**Amendment C159: Rezone land at 1
Jacksons Road, Mulgrave and 636
Wellington Road Mulgrave**

**Submission by Planning Authority for Planning Panel -
Part B**

17 April 2020

**CITY OF
MONASH**

Figure 1 Example built form requirements (Precinct C)

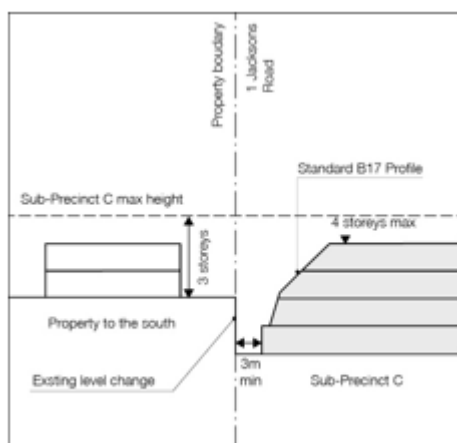
2.2.5 Proposed DDO16 addresses the issue of building height by proposing that building heights around the periphery of the site have regard to the 3 storey maximum height in these adjacent areas. Figure 2 below shows one of the interface areas and how a four storey building on the site will be no higher than two to three storeys in the adjacent residential areas, due to the difference in site levels. In addition, higher levels of the building would be required to set back further from the boundary.

2.2.6 Proposed higher built form and the six storey height areas are located towards the centre of the site, some 20 metres from the western and southern boundaries of the site.
